DCN No. E990439-00-D

DOCUMENT CHANGE NOTICE (DCN)

DOCUMENT No. (DOC-REV-GP. ID)	TITLE	NEW REV.
D970618-A-D	Sensor/Actuator Spacer	B

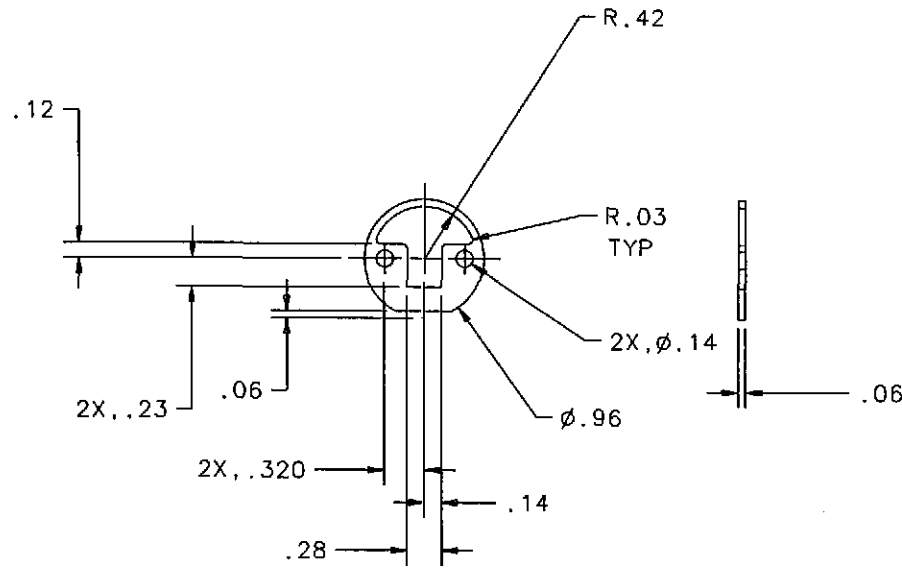
CHANGE DESCRIPTION (FROM/TO): Change thickness from .12 to .06. Remove pin clearance holes and add one large clearance hole. Remove .06 from the bottom.

REASON FOR CHANGE: easier to machine
